Technical Service Bulletin SB-73 Repair Instructions

Models Involved: 2023 - 2024 Convoy motorhomes and certain 2023 - 2024 Tiffin GH1 motorhomes built between March 21, 2023 and April 8, 2024.

Purpose: To provide instructions on how to remove the incorrectly rated flexible water lines on the Aqua-Hot Hydronic Heating System heat exchanger and replace them with pex lines that have the correct heat ratings.

SB-73 2023-2024 Convoy & 2023-2024 Tiffin GH1 Flexible Water Line Replacement

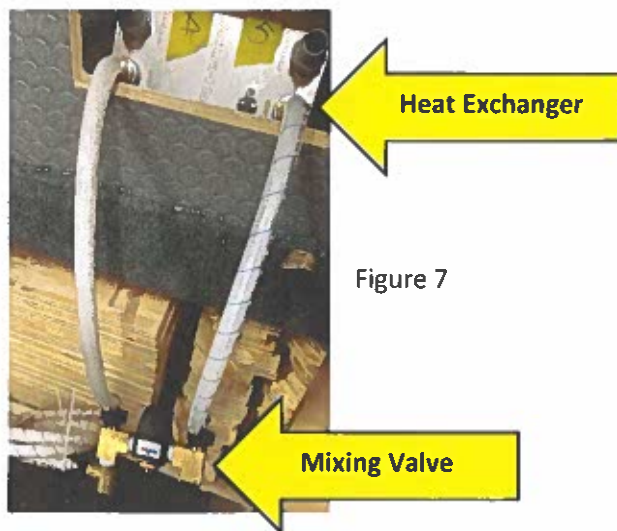
7. Build the new heat exchanger line assemblies as shown in (Figure 6) below. Place the ½" crimp ring over the Pex tubing. Insert the barbed ½" fitting into the Pex pipe on the same end. Crimp the ring directly over the fitting's location (about 1/8" from the outside edge of the tubing). The fitting should be tight enough it cannot be removed by hand.
